# CITY OF PORTLAND, MAINE

## PLANNING BOARD

Project Name: New Dunkin' Donuts Restaurant with drive-through  
Project ID: Project # PLO00047-2018 (Site Plan) and CU-000172-2018 (Conditional Use)  
Address: 325 St John Street, Portland CBL: 065 Coo4001  
Applicant: Dunkin' Brands, Inc. (Robert Mahoney)  
Planner: Jean Fraser

# PLANNING BOARD REPORT PORTLAND, MAINE

## Plan 4 Landscape:

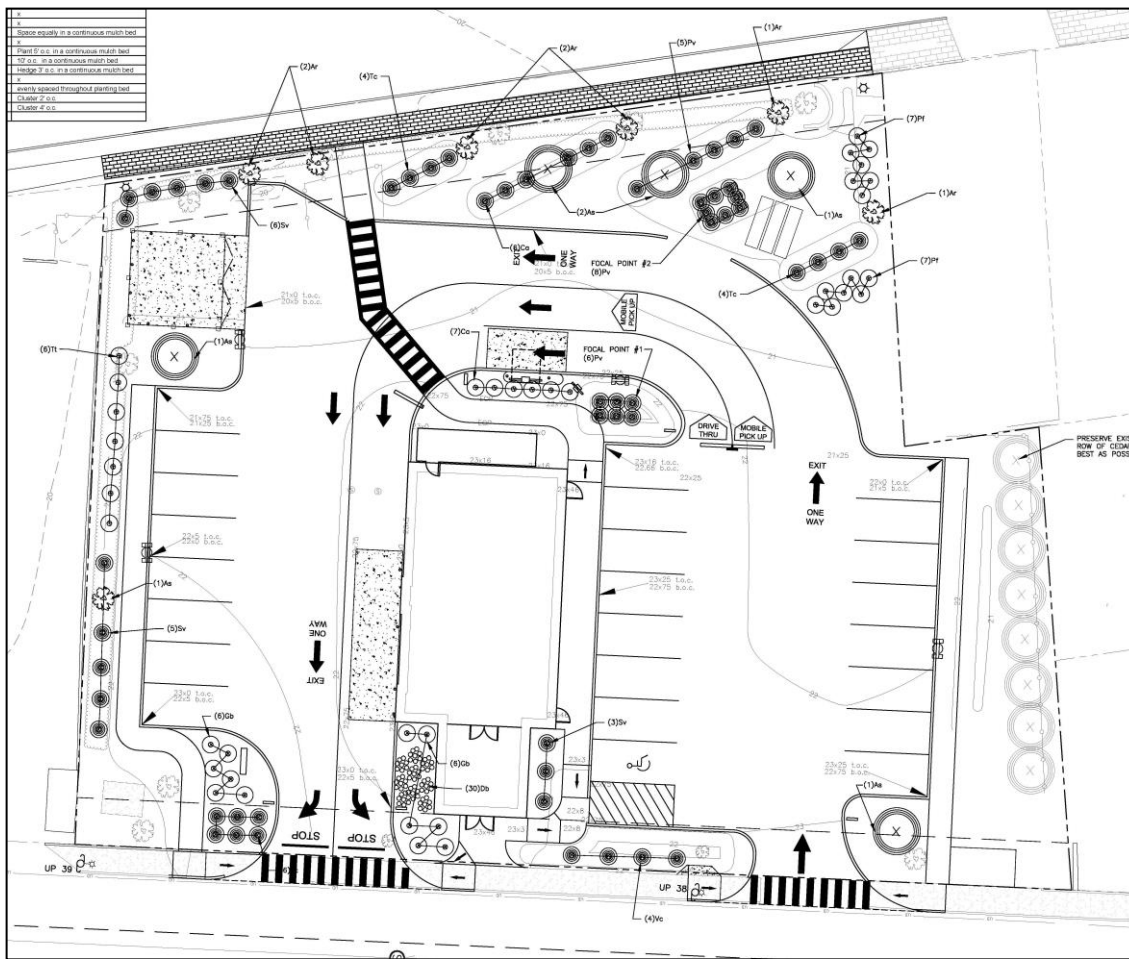
The Landscape Plan is extracted above (under "Proposals") and indicates new planting, which has been revised substantially since the Planning Board Workshop to address the City Arborist comments (Attachment 3) and to achieve the following objectives:

It is noted that although a new tree has been planted near the dumpster enclosure, the enclosure remains chain link without any screen planting. A suggested condition of approval requires that either the enclosure is upgraded to wood materials, or screened with planting, with the final proposals subject to final staff review and approval.

3. That the applicant shall submit a revised Landscape Plan, for review and approval by the City Arborist and the Planning Authority, to improve the appearance of the dumpster enclosure either through upgraded materials or landscape screening.
